Increasing the Damping Time for the ISI Watchdogs

T1700481-v3, Nov. 6, 2017

1 Summary

Figure 3: Detail of the updated watchdog screen highlighting the countdown timers for the two stages, and the pending reset indicators

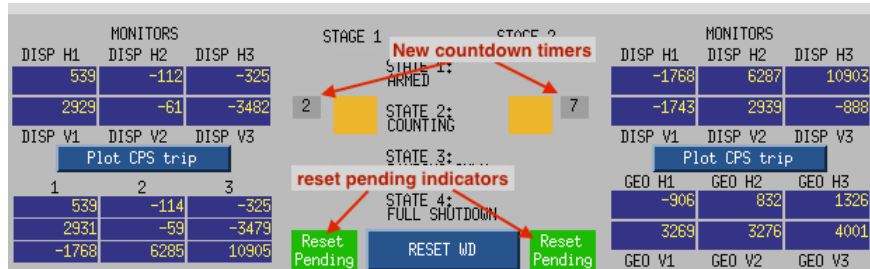
The Watchdog MEDM screen has been updated to show the timing and reset status during the stage 2 ‘damp-hold’ time. Figure 3 shows a detail of the BSC-ISI watchdog screen when the system is counting in state 2 and a reset has been requested. The countdown timers are different because this system has a 5 second delay before the stage 1 watchdog trips the stage 2 watchdog.

Figure 4: BSC-ISI watchdog when all is well. Note the new delay time input by the stage 2 indicator of a stage 1 trip.

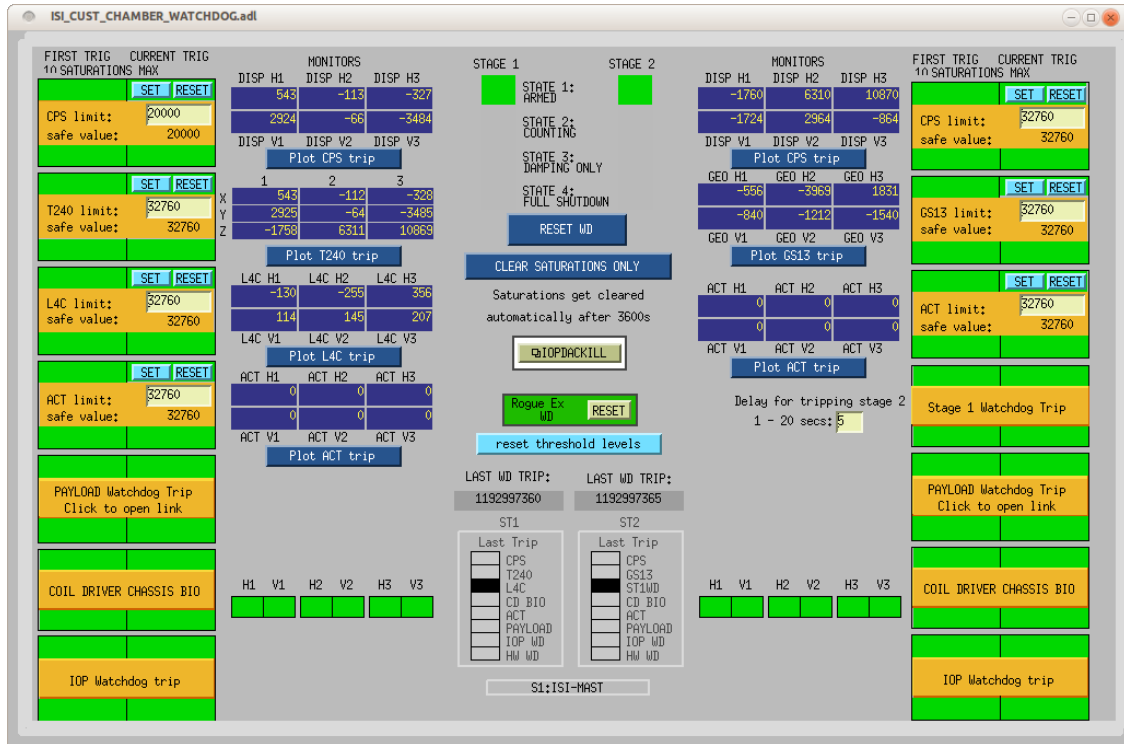
The MEDM screen for the watchdog has been updated slightly. We have added a countdown timer which is visible in state 2, a flag indicating that there is a reset pending, and a new input for the time delay for stage 1 tripping stage 2. The updated BSC-ISI watchdog screen can be seen in figures 4 - 6. The HAM Watchdog screen has also been updated, and a view of this can be seen below in figure 7.

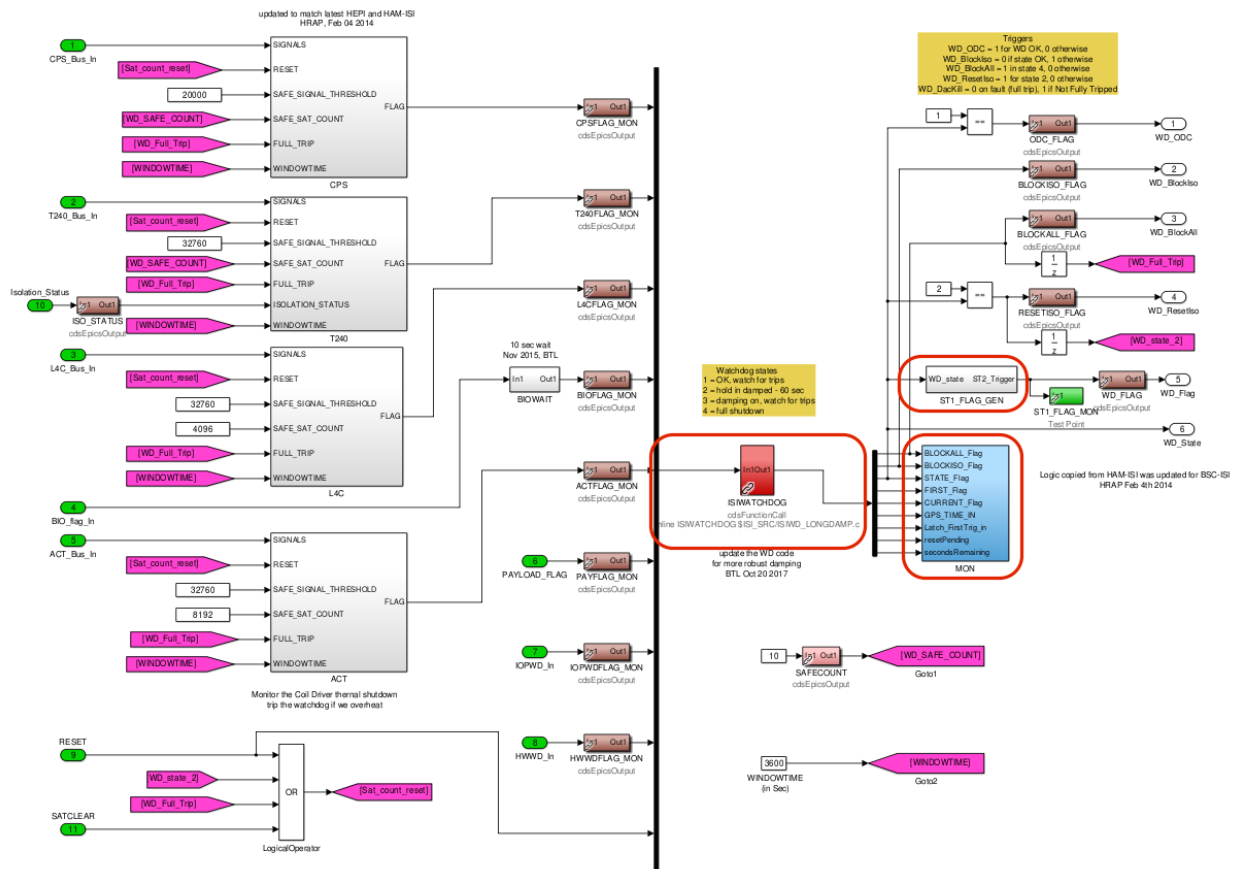
The new watchdog c-code has two new outputs - a monitor for the time remaining in state 2 and a monitor for the watchdog pending flag. Because the number of outputs has changed, I have changed the name of the c-code file. These changes can be seen in the watchdog for block for BSC-ISI stage 1, shown below in figure 8. The only changes for the the HAM-ISI watchdog and for the watchdog on Stage 2 of the BSC-ISI are the new c-code and a expanded monitor block. There is a good deal of new code in the new `ST1_FLAG_GEN` code block. This path used to just send a steady '1' to the stage 2 watchdog when the stage 1 watchdog was in any of the tripped states. Now, it will send a short pulse of '1' to stage 2 after a few seconds of continuous stage 1 WD trip. This pulse will trip stage 2, but then it will return to a '0' level, so stage 2 will only proceed to 'Full-trip' if a fresh trigger arrives, e.g. from a stage 2 saturation. The code for this flag generator block is shown in figure 9. The delay time is held in a single epics variable called `ifo:ISI-chamber.ST1.WD.ST1_FLAG_GEN_DELAY_TIME`. If the user specifies a delay time outside of the min-to-max range specified, the simulink code will reset the value of this epics variable to the in-range value on the next clock cycle. I think this is new functionality; the code is shown in figure 10.

Figure 9: ST1_FLAG_GEN Simulink block. This generates a pulse when the stage 1 WD has been tripped for the specified DELAY time.

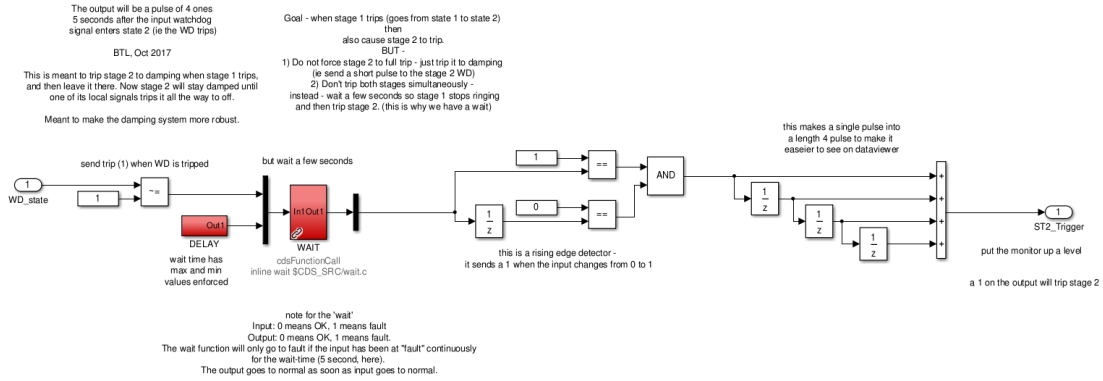
The other change is that, since there can be large impulses when the isolation loops are shut down, there is a short delay between the trip of the stage 1 watchdog and the automatic trip of the stage 2 watchdog. It is not clear what the optimal delay is, so this can be set by the user in the range of 1 - 20 seconds. The simulink code for this is included below. The variable which holds the time delay is *ifo:ISI-chamber_ST1_WD_ST1_FLAG_GEN_DELAY_TIME* and can be seen on the Watchdog screen. The max and min values are hard coded into the simulink diagram.
